BOARD ACTION REPORT – APPEALABLE ITEM

Project Name: Gunther Volvo
Project Location: 2201 North Federal Highway
Request: Class V Site Plan Modification
Board: Site Plan Review and Appearance Board
Meeting Date: May 10, 2017

---STAFF REPORT---

ITEM: **Gunther Volvo (2017-009)** – Class V Site Plan Modification for the construction of a 31,035 square foot Showroom/Service building, and a three level parking garage at 2201 North Federal Highway.

LANDSCAPE
PLAN

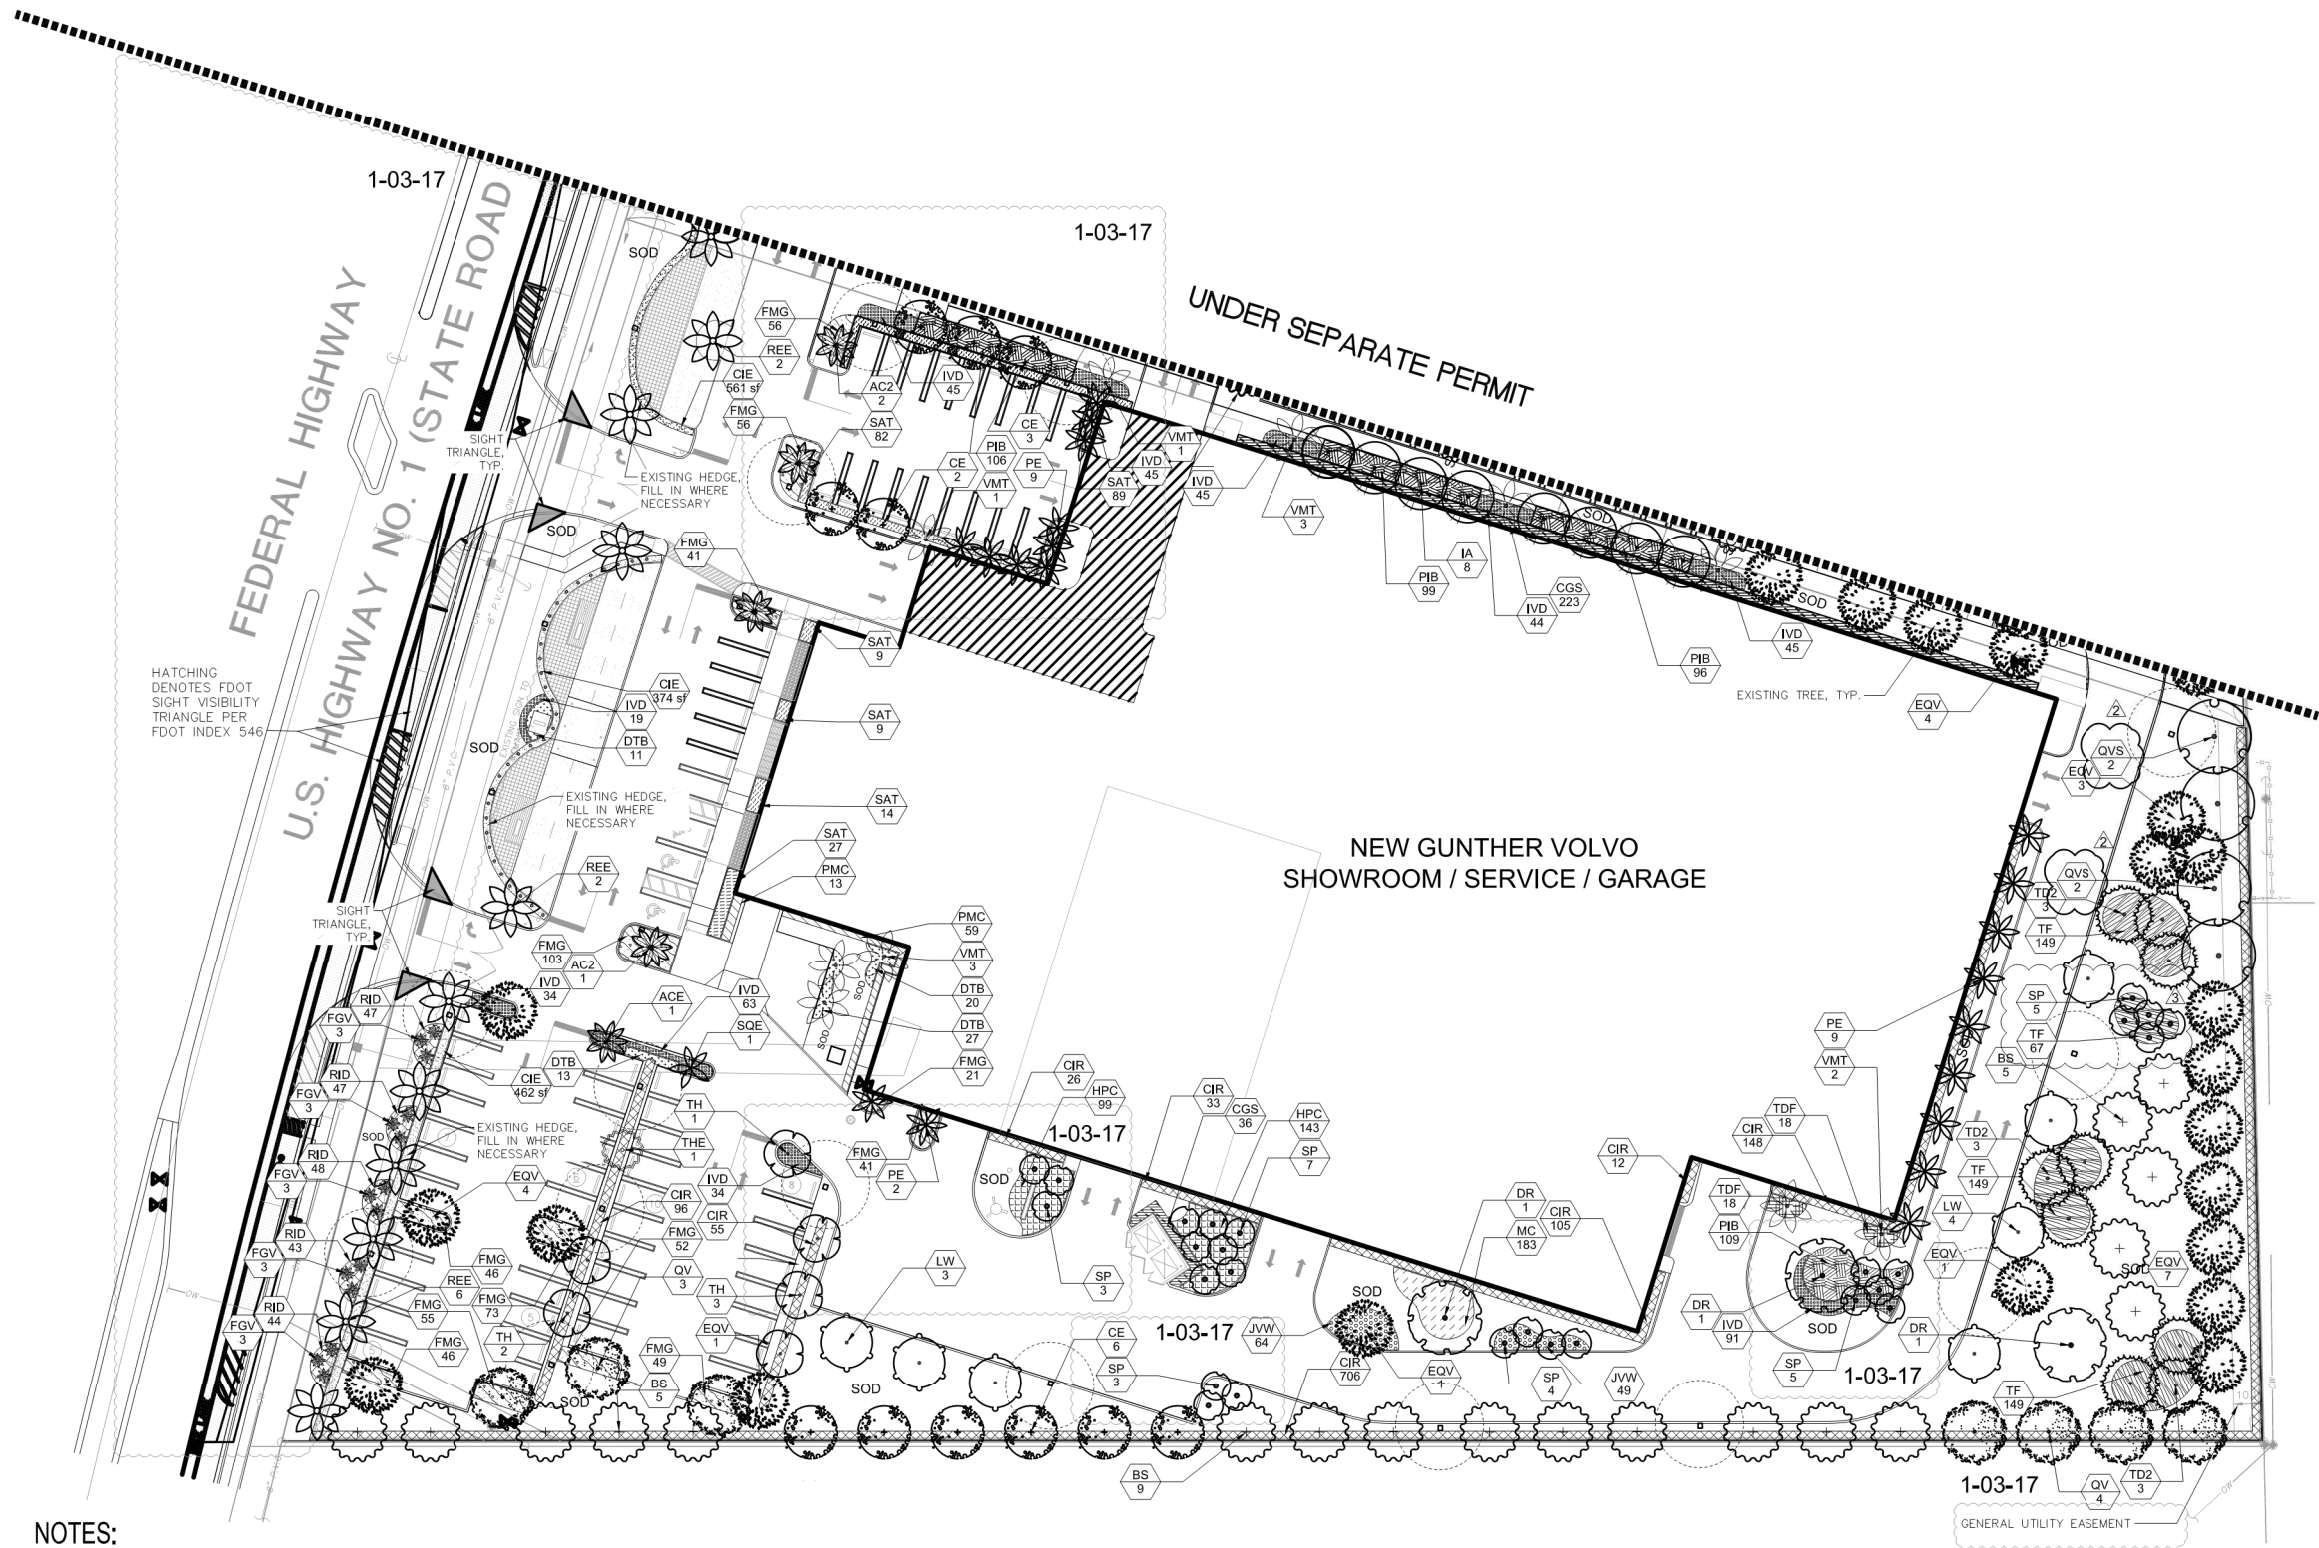
Gunther Volvo also proposes adding trees, but I question whether that is really a design change. I do not believe the Landscape Plan has been approved by Delray at this point.

Additionally the trees are shown to be planted in the Retention Basin, which is probably not allowed and is largely ineffective.

SCREEN WALL DETAIL - EAST ONLY

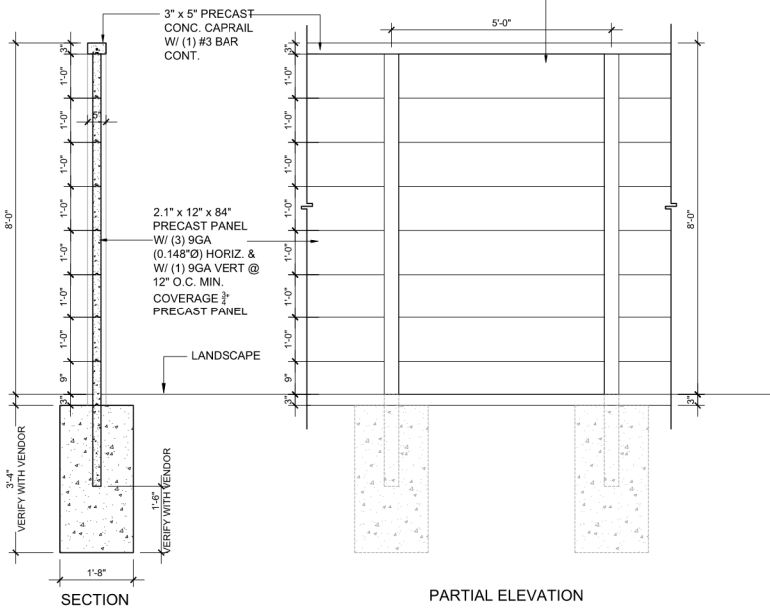
- **Increase in height of the wall on the east property line.** The initial proposal provided for a 6-foot wall. Gunther increased the height of the wall to 8 feet to further remove the visual and sound impact of the new dealership from the neighborhood to the east.

NOTE:
HEIGHT INCREASE ON EAST PERIMETER
WALL IS DUE TO SUGGESTIONS MADE BY
TOWN OF GULF STREAM AND ITS RESIDENTS
